Release Notes for MPiec controller firmware

Release 3.1.0 builds 124,125, and 127

Sept. 10, 2015.

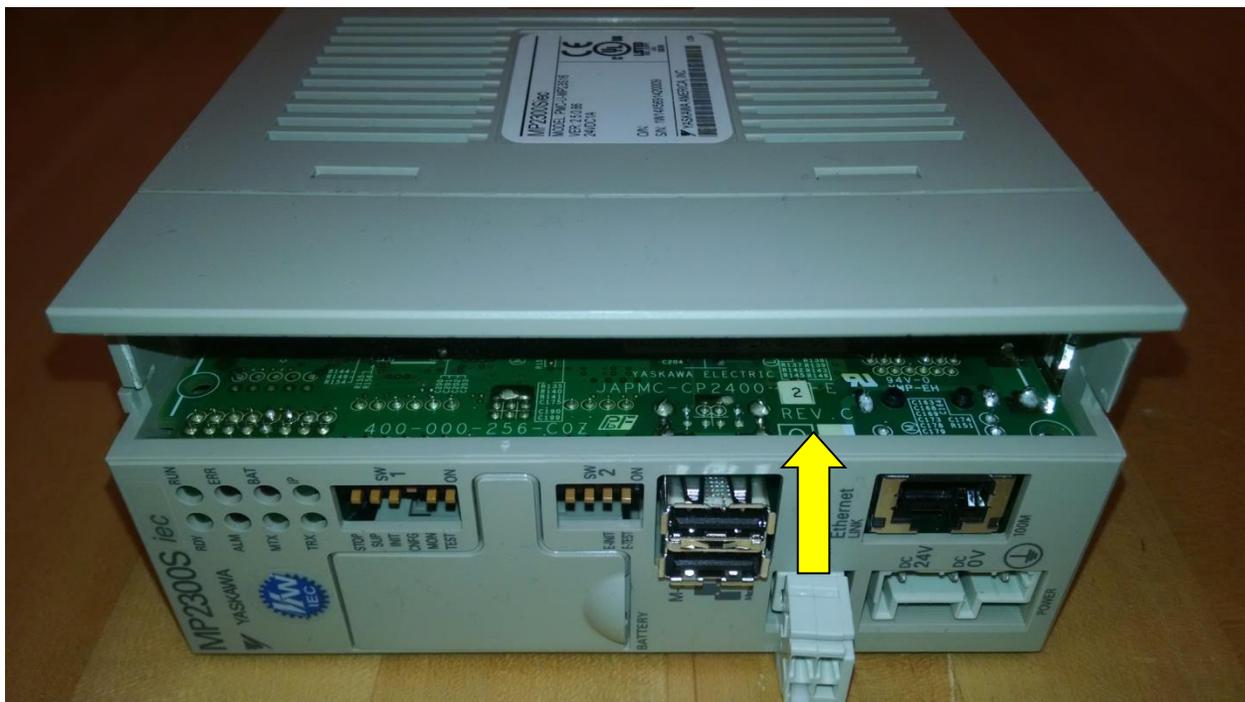
This release includes an Ethernet-related bug fix (8809) for the MP2300Siec and MP2310iec controllers with rev C hardware only. To determine if the MP2300 controller has rev C hardware, look at the silkscreen of the CPU board as shown below.
